Community Engagement Key Findings Report -

Exhibition of draft Fairfield Village Built Form Guidelines & Heritage Assessment recommendations, September-October 2017

Objective Document ID Number	A4345970
Responsible Officer	Gilda Di Vincenzo
Custodians	City Design & Strategic Planning Unit
Date/s Issued and/or Communicated	27 November 2017
Version Number	1.1

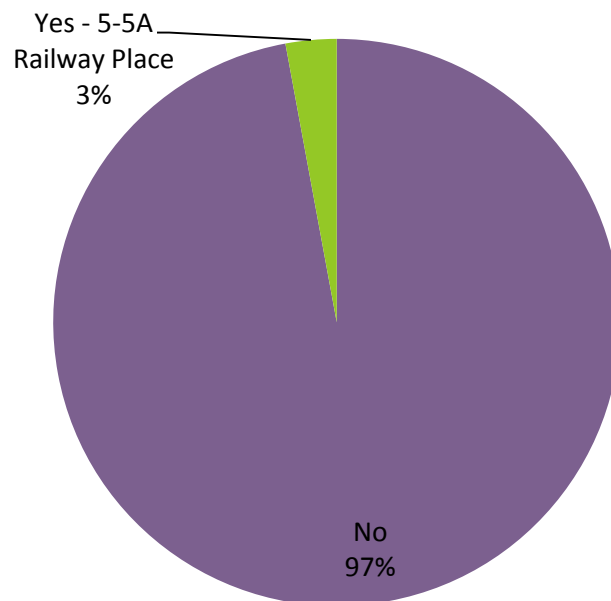
5 and 5a Railway Place is not a 'significant' heritage building. Its inclusion as 'significant' seems solely justified by the fact that it is separated from the other 'contributory' heritage buildings by the Grocon development at 7-9 Railway Place; and to include it in the heritage precinct its heritage status has had to be elevated beyond its real integrity. The 5 and 5a building is in good renovated condition, not 'intact with historical integrity'. ie *

- * The 3 tiers of 'early glazed faience facing' have largely been replaced with similar Chinese 'Steele Green' tiles from Schotts;
- * the stall-board tiles have been removed and the stall-boards rendered;
- * the original copper/brass window frames have been replaced with an aluminium window frame;
- * the original ingoe doors insets have been replaced by flush doors on both sides;
- * The doors themselves have been replaced with wooden framed doors;
- * the original encaustic tiled floor entries have been removed and the area incorporated into the internal space;
- * the verandah has been replaced.

5 and 5a Railway Place present a modest single storey shop/residence similar to many others throughout the City of Darebin (and indeed inner Melbourne) considered to be of an interesting aesthetic, rather than significant heritage category. There are no features of 5 and 5a Railway Place which set them apart (nor elevate their status) from the 'contributory' buildings in Railway Place, such as 11, 17-17a, 21-23, 25, et al. The inclusion is an anomaly. The Fairfield Village Heritage Assessment Report (June 2017) assessment of 5 and 5a Railway Place as '...a very intact interwar shop...' is incorrect as can be seen above (a well renovated modest premise is a more apt description). As the Fairfield Village Heritage Assessment Report states, 5-5a is '...visually separated from other historic shops in Railway Place by a large development at 7-9 Railway Place...', '...which is significantly out of character in scale and height...', and '...visually isolates the last three properties in Railway Place.' (ie 5-5a, 3, and 1 Railway Place). This further diminishes the citation of 5 and 5a Railway Place as 'significant' and supports the exclusion of this property all together.

AREA AND ISSUES RECOMMENDED TO BE COVERED IN A COMPREHENSIVE MASTERPLAN OF FAIRFIELD VILLAGE
(based on City of Darebin Draft Built Form Guidelines - Valued Street Facade Plan)

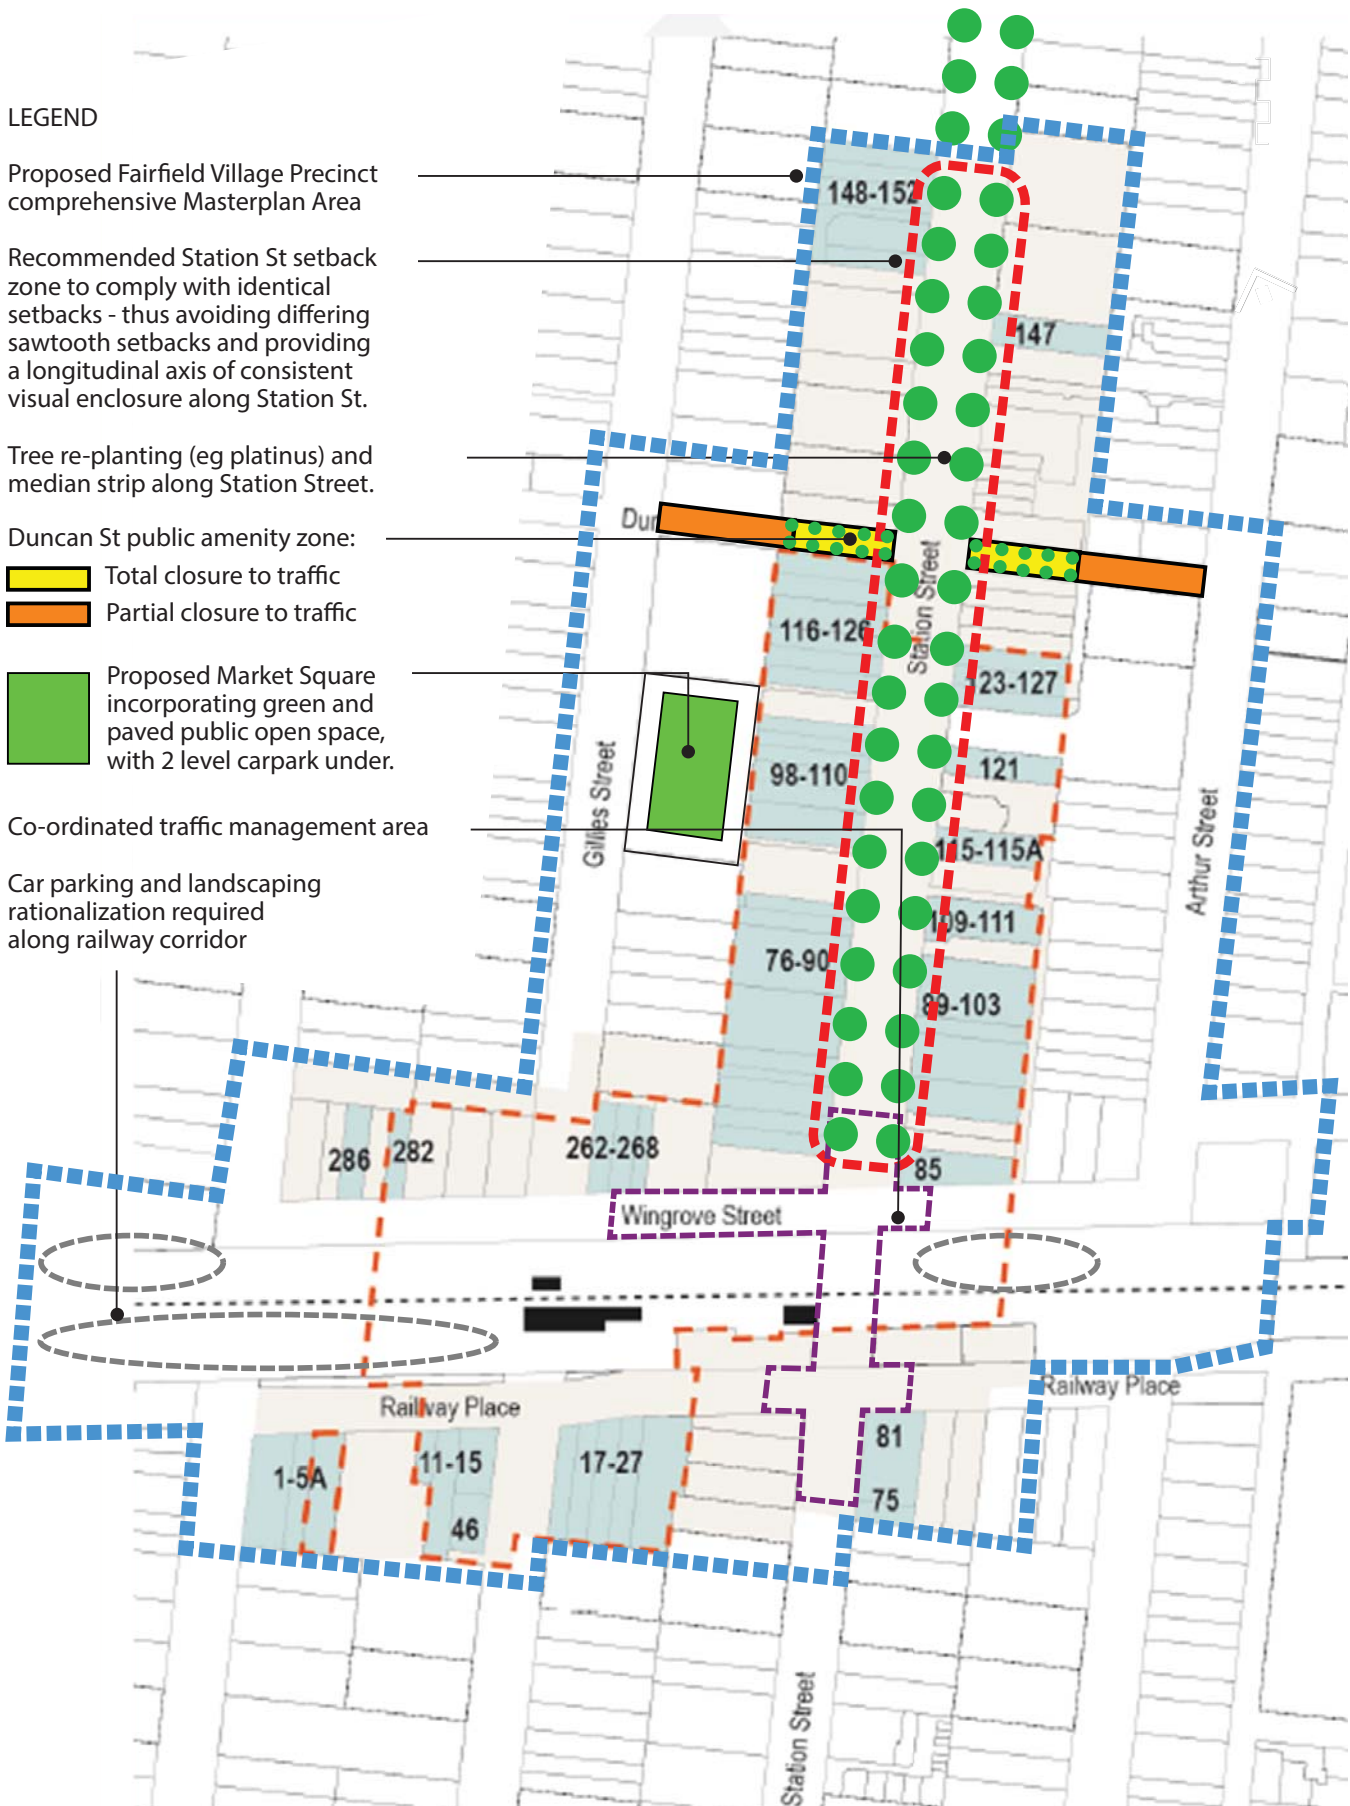
Proposed Fairfield Village Precinct comprehensive Masterplan Area

Recommended Station St setback zone to comply with identical setbacks - thus avoiding differing sawtooth setbacks and providing a longitudinal axis of consistent visual enclosure along Station St.

Tree re-planting (eg platinus) and median strip along Station Street.

Duncan St public amenity zone:

- Total closure to traffic
- Partial closure to traffic

Figure 3.11. Map of the Fairfield Village Heritage Precinct developed and documented in Stage Two.

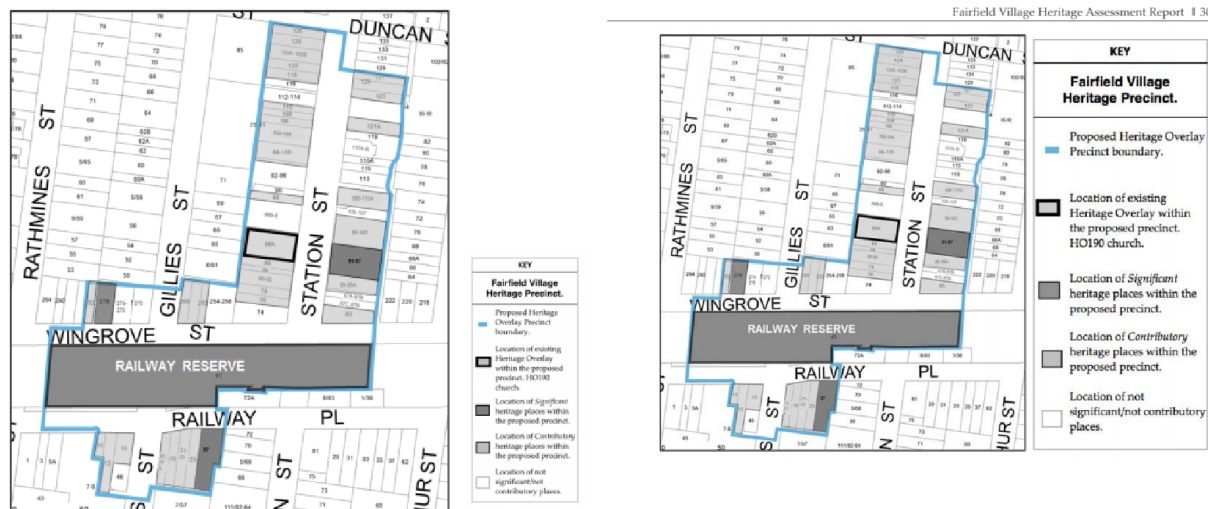
Introduction: 5 & 5a Railway Place Fairfield appears to be a late AND arbitrary inclusion in the Fairfield Village Heritage Precinct and the ASSOCIATED Heritage Assessment Report. The property does not appear in the Heritage Precinct Stage 1, nor the recommended amendments Stage 2 (see i below), nor the 'developed and documented' Fairfield Village Heritage Precinct Stage 2 (see ii below).

i. Recommended Amendments Stage 2

ii. Fairfield Village Heritage Precinct 'developed and documented' Stage 2.

Figure 3.12. Detail diagram of the 'Village Square', Fairfield Village Heritage Precinct developed and documented in Stage Two.

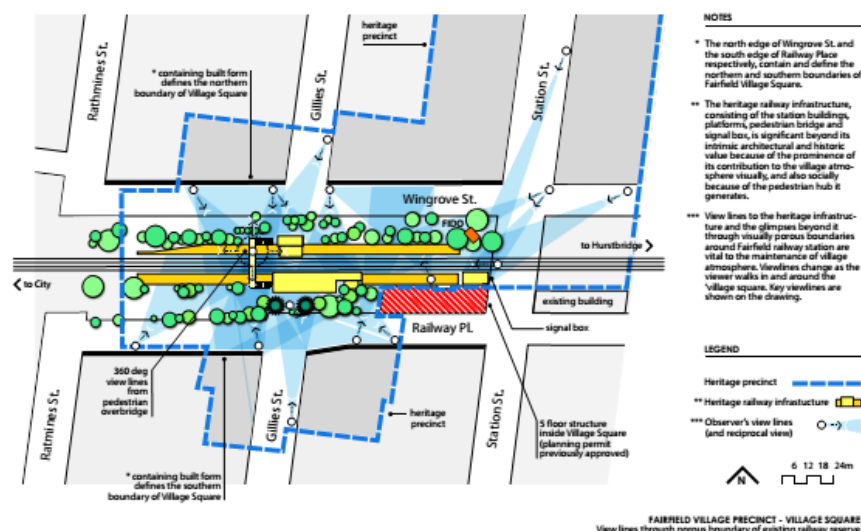
Neither is the property listed in the Fairfield Village Heritage Precinct 'Village Square' 'developed and documented' Stage 2 (see Figure 3.12 below).

5 and 5a Railway Place is assessed in the Fairfield Village Heritage Assessment Report (June 2017) as a '...a very intact interwar shop...'. The assessment appears to have missed or overlooked the very significant changes to the premises' façade in the last 40 years.
